**CITY PLAN COMMISSION****THURSDAY, JANUARY 23, 2025****FILE NUMBER:** S245-056**SENIOR PLANNER:** Hema Sharma**LOCATION:** Forth Worth Avenue at Sylvan Avenue, south of Seale Street**DATE FILED:** December 26, 2024**ZONING:** PD 714 (Subarea 2A), CS**PD LINK:** <https://dallascityhall.com/departments/city-attorney/Articles/PDF/Article%20714.pdf>**CITY COUNCIL DISTRICT:** 6**SIZE OF REQUEST:** 4.9998-acres**APPLICANT/OWNER:** Diamond Belmont Holdings, LLC

**REQUEST:** An application to replat a 4.9998-acre tract of land containing all of Lot 36 in City Block A/4015, all of Lot 1A in City Block B/4017 and all of Lot 2A in City Block C/4018 to create one lot on property located on Forth Worth Avenue at Sylvan avenue, south of Seale Street.

Map and legal description of Lot 1, Block A4017, Belmont Addition. Includes owner information, survey details, and a preliminary plat for the City of Dallas.

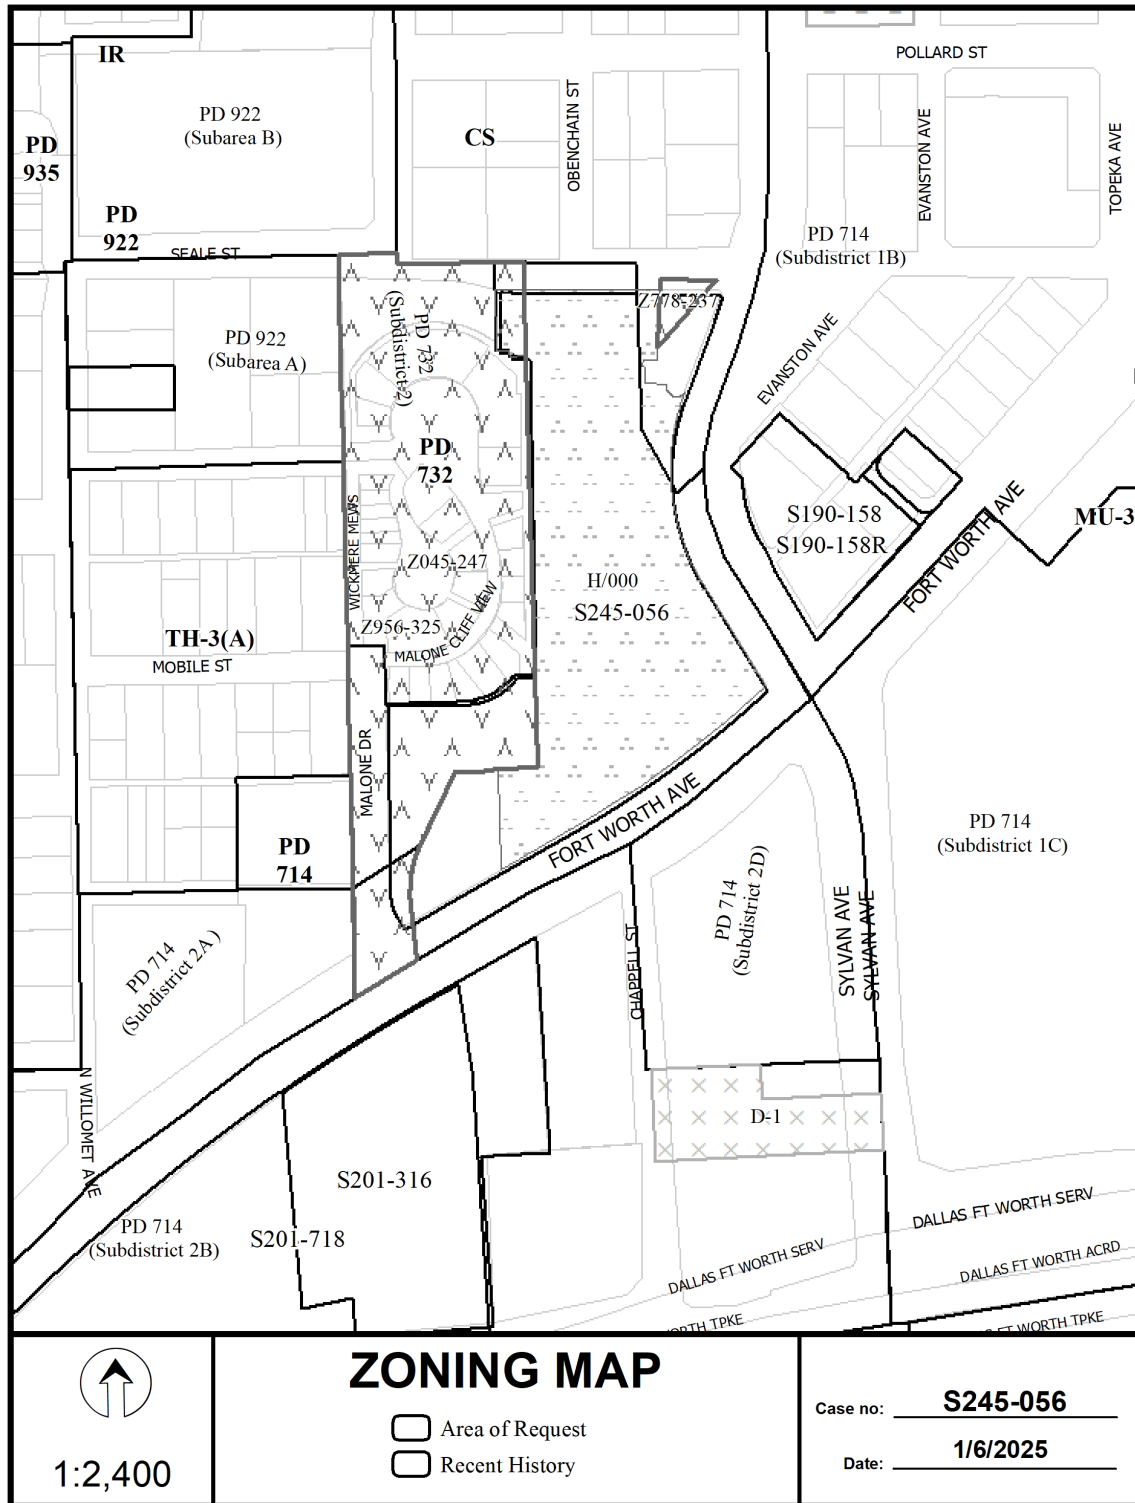
**STAFF RECOMMENDATION:** The request complies with the requirements of the PD 714 (Subarea 2A), CS Commercial Service District; therefore, staff recommends approval of the request subject to compliance with the following conditions:

5. Any new or existing structure may not extend across new property lines. *Section 51A-8.503(e)*
6. On the final plat, all easement abandonments, and ROW abandonments must be by separate instrument with the recording information shown on the face of the plat. A release from the Real Estate Division is required prior to the plat being submitted to the Chairman for signature.

7. On the final plat, include two boundary corners tagged with these coordinates: "Texas State Plane Coordinate System, North Central Zone, North American Datum of 1983 on Grid Coordinate values, No Scale and no Projection."

8. On the final plat, monument all set corners per the Monumentation Ordinance. Prior to submittal of the final plat for the Chairman's signature. The monuments must be verified by the Chief City Surveyors Office in the Public Works Department. *Section 51A-8.617*

11. The number of lots permitted by this plat is one.

13. Detention may be required if the capacity of available outfall is not adequate to carry the developed runoff. Section 51A-8.611(c).
14. Place a note on the final plat stating "Lot-to-Lot drainage will not be allowed without proper City of Dallas Engineering Division approval" 51A 8.611(e)

15. On the final plat, dedicate 50 feet of right-of-way (via fee simple) from the established center line of Sylvan Avenue. *Section 51A 8.602(c)*
16. On the final plat, dedicate 28 feet of right-of-way (via fee simple or street easement) from the established centerline of Seale Street. *Sections 51A-8.602(c), 51A-8.604(c) and 51A-8.611(c).*

17. On the final plat, dedicate a minimum 10-foot by 10-foot corner clip (via fee simple or street easement) at the intersection of Sylvan Ave & Seale Street Place. Section 51A 8.602(d)(1)

18. On the final plat, dedicate a minimum 15-foot by 15-foot corner clip (via fee simple or street easement) at the intersection of Sylvan Ave & Fort Worth Avenue. Section 51A 8.062(d)(1)

19. On the final plat, dedicate a minimum 10-foot by 10-foot corner clip (via fee simple or street easement) at the intersection of Fort Worth Avenue & Malone Drive. Section 51A 8.062(d)(1)

20. On the final plat, add the note: "TxDOT approval may be required for any driveway modification or new access point(s)." No citation.
21. Must coordinate with Transportation Department for any traffic signal requirements that are deemed necessary for improving pedestrian accessibility and safety related to site development (Contact Srinivasa Veeramallu with Traffic Signals). *51A-8.606, 51A-8.608*

22. Prior to final plat, submit a completed final plat checklist and all supporting documents.
23. On the final plat, show how all adjoining right-of-way was created. Section 51A-8.403(a)(1)(A)(xxii).
24. On the final plat, show distances/width across all adjoining right-of-way. Platting Guidelines.
25. On the final plat, show recording information on all existing easements within 150 feet of the property.
26. On the final plat, show all additions or tracts of land within 150 feet of the property with recording information. Platting Guidelines.
27. On the final plat, chose a new or different addition name.

28. Additional design information is required for assessment. Site plan must be submitted showing proposed development, building finished floor elevation, development, existing mains – including downstream manhole, and proposed water and wastewater service locations. Submit water/wastewater engineering plans to 320 E. Jefferson Blvd., Room 200, Attention: Water and Wastewater Engineering.
29. Water and Wastewater main improvements may be required by Private Development Contract. Submit water/wastewater engineering plans to 320 E. Jefferson Blvd., Room 200, Attention: Water and Wastewater Engineering.

30. Prior to the final plat, please provide tree survey.
31. On the final plat, change “Seale Street” to “Seale Street (FKA Terrell Street FKA Grove Street)”. Section 51A-8.403(a)(1)(A)(xii).
32. On the final plat, change “Sylvan Avenue” to “Sylvan Avenue (AKA Sylvan Street FKA Obenchain Street)”. Section 51A-8.403(a)(1)(A)(xii).
33. On the final plat, change “Fort Worth Avenue (FKA State Loop 260 & Dallas Avenue-Fort Worth Pike)” to “Forth Worth Avenue (AKA Forth Worth Cutoff FKA West Dallas Pike) – Provide documentation for Dallas Avenue and State Highway Loop No. 260”. Section 51A-8.403(a)(1)(A)(xii).
34. On the final plat, add “Evanston Avenue (FKA Sylvan Street)” to plat drawing.
35. On the final plat, add “Wickmere Mews” to plat drawing.
36. On the final plat, add “Malone Cliff View” to plat drawing.
37. On the final plat, identify the property as Lot 1B in City Block B/4017.
